Announcement

Specification change: LF1A series LED illumination units

IDEC would like to inform you of a few specification changes regarding our LF1A series LED illumination units. Details are as follows:

- Appearance example (e.g., LF1A-D-* 300mm type)

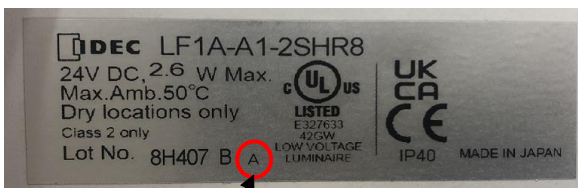
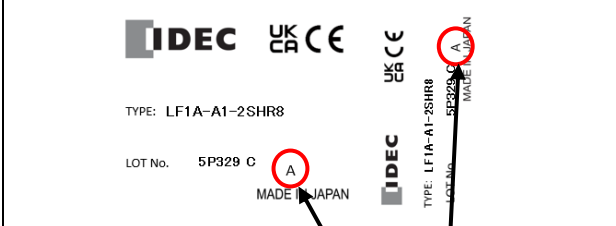
The diffuser board appearance and reference illuminance will be changed as below.

Current	
New
